UNITED STATES PATENT AND TRADEMARK OFFICE

APPLICATION NO.	FILING DATE	FIRST NAMED INVENTOR	ATTORNEY DOCKET NO.	CONFIRMATION NO.
10/796,692	03/09/2004	Colby Nash	FY.51040US1A	2923
20995 7590 05/09/2007 KNOBBE MARTENS OLSON & BEAR LLP 2040 MAIN STREET FOURTEENTH FLOOR IRVINE, CA 92614			EXAMINER BROWN, DREW J	
			ART UNIT 3616	PAPER NUMBER
			NOTIFICATION DATE 05/09/2007	DELIVERY MODE ELECTRONIC

Office Action Summary

DETAILED ACTION

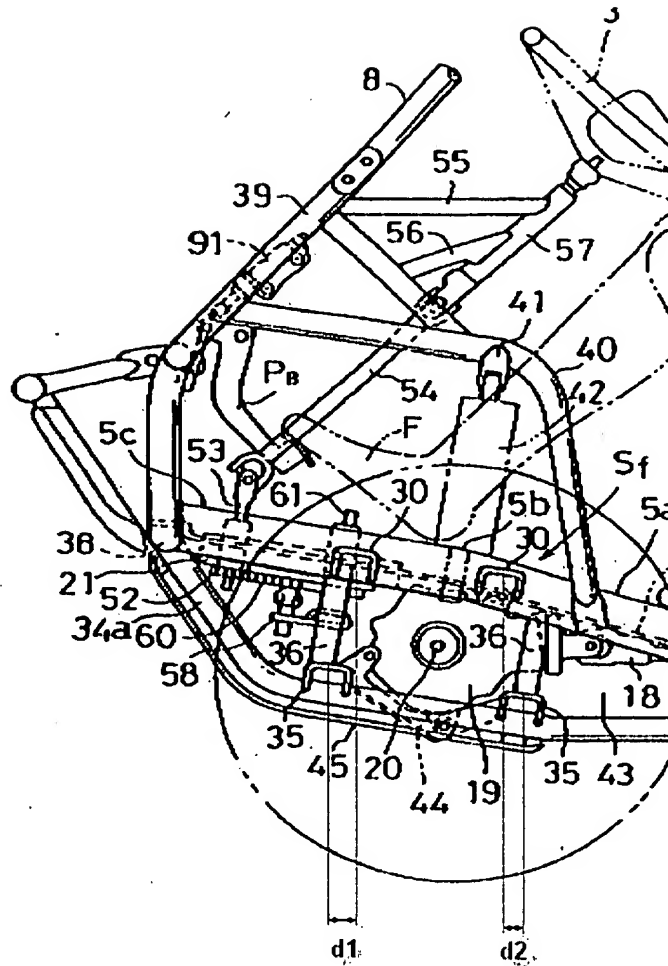
With respect to claim 1 and 32, Furuhashi et al. discloses an off-road vehicle comprises a frame (1) extending generally fore to aft, at least one wheel (2), and first (31)

and second (33) suspension arms, each including a plurality of ends and being configured to suspend the wheel from the frame (Figure 4), the frame including two frame members (5 and 34) extending generally fore to aft, the vehicle further comprising front (30) and rear (35) sets of retainers being coupled to the frame members, the retainers of at least one of the front and rear sets being spaced apart from each other in a fore-to-aft direction with a fore-to-aft spacing between the retainers of the rear set (Figure 5), each retainer of the front set being configured to retain an end of a respective suspension arm (31) and each retainer of the rear set being configured to retain an end of a respective suspension arm (33) so as to permit the respective suspension arm to swing relative to the respective set of retainers (Figure 4). A front retainer of each set is configured to retain a front end of a respective suspension arm in a manner permitting the respective suspension arm to swing relative to the respective set of retainers (Figure 4), the front retainers being spaced apart from each other in a fore to aft direction by a distance which is different than a distance by which the rear retainers are spaced apart from each other in a fore to aft direction ($d1 > d2$ as shown in Figure below).

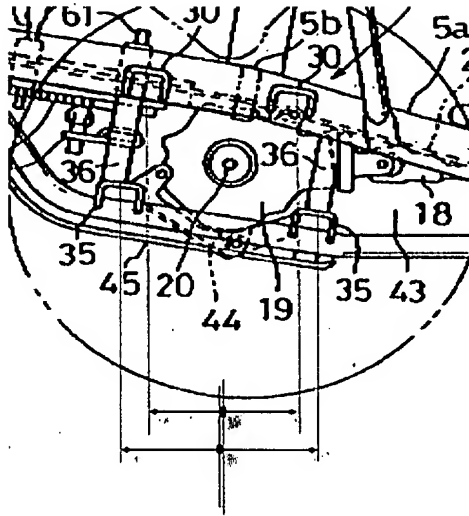
With respect to claim 36, a frame (10) and upper (31) and lower (33) suspension arms, the frame extending generally horizontally fore to aft, the upper and lower suspension arms each including two ends being pivotally coupled to the frame (Figure 4), the ends of upper suspensions arm being spaced apart from each other fore to aft at a first length, the ends of the lower suspension arm being spaced apart from each other fore to aft at a second length, wherein a midpoint of the first length is not aligned with a midpoint of the second length along a vertical line (see Figure below).
